# VS-1202S audio switching improvement.

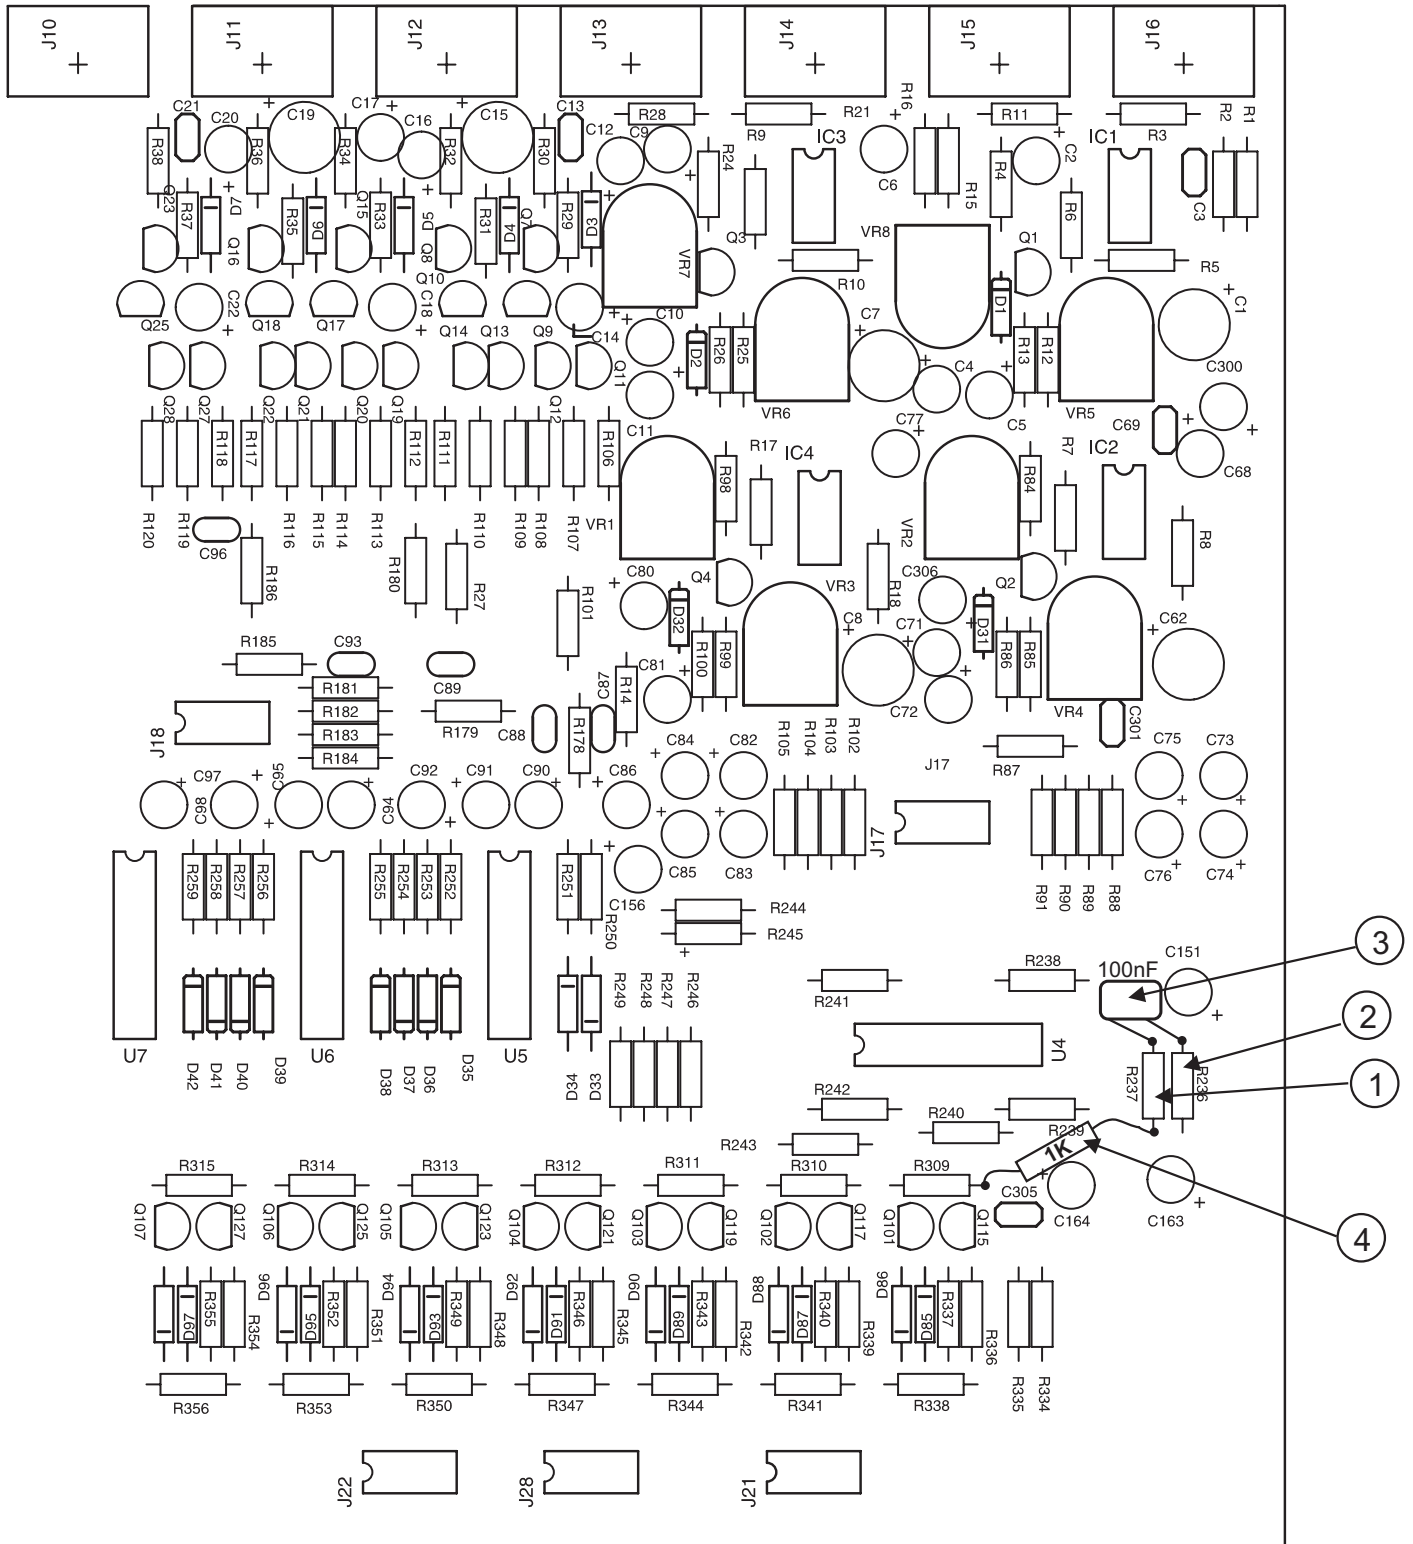
1. Remove R237 From Board if it is present.
2. Remove R236 From Board, if it is present.
3. Solder a 100nF capacitor as shown.
4. Connect a 1K/5%/0.25W resistor as indicated in drawing, between R309 and R237. If there was a jumper at this location, remove it and replace with the 1K resistor.
